SITE DEVELOPMENT PLAN AMENDMENT 3
HILLSIDE-ARBORS SITE DEVELOPMENT PLAN

TRACTS K-1, L, & M, HILLSIDE/ARBORS AMENDMENT NO.1
HILLSIDE-ARBORS PHASES 3 & 4
LOCATED IN THE SOUTHWEST 1/4 OF SECTION 3 AND THE SOUTHEAST 1/4 OF SECTION 4,TOWNSHIP 8 SOUTH, RANGE 67 WEST OF THE 6TH P.M.,TOWN OF CASTLE ROCK , COUNTY OF DOUGLAS, STATE OF COLORADO

SITE DEVELOPMENT PLAN AMENDMENT 3
TOWN OF CASTLE ROCK PROJECT NO. SDP25-012

SITE DEVELOPMENT PLAN AMENDMENT 3
COVER SHEET

1 MASTER CONCEPTUAL LANDSCAPE PLAN

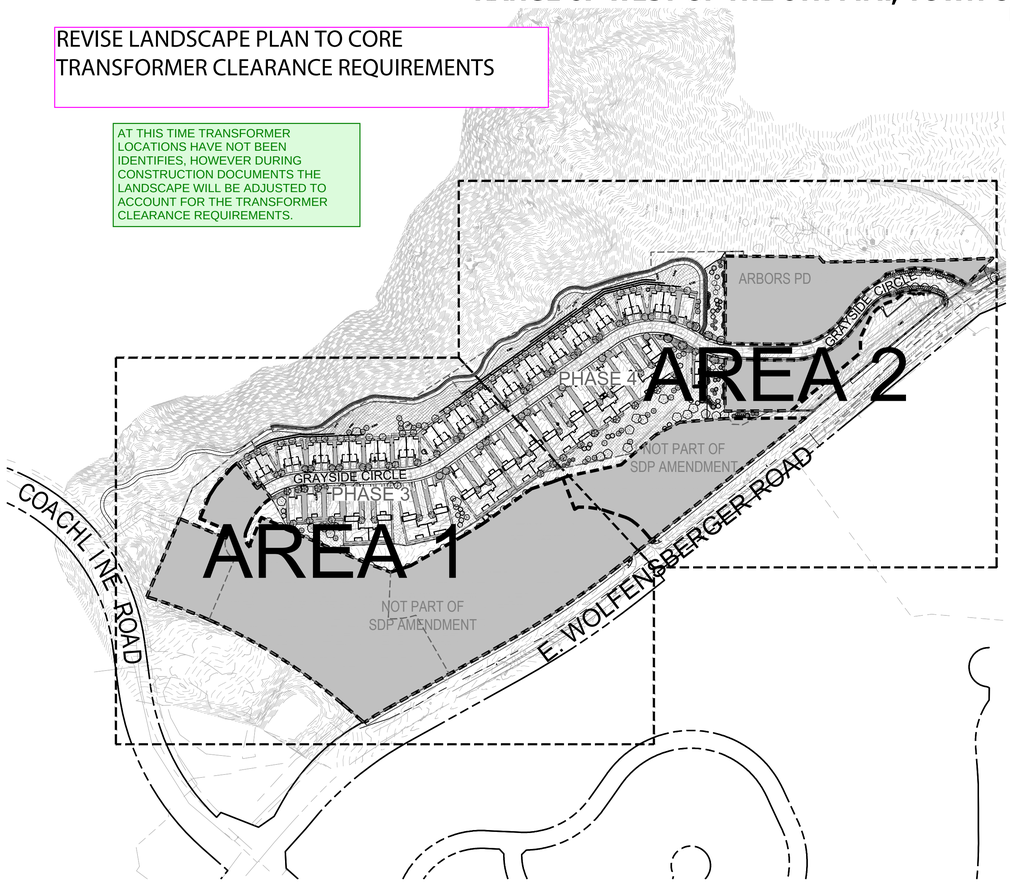
REVISE LANDSCAPE PLAN TO CORE TRANSFORMER CLEARANCE REQUIREMENTS

AT THIS TIME TRANSFORMER LOCATIONS HAVE NOT BEEN IDENTIFIES, HOWEVER DURING CONSTRUCTION DOCUMENTS THE LANDSCAPE WILL BE ADJUSTED TO ACCOUNT FOR THE TRANSFORMER CLEARANCE REQUIREMENTS.
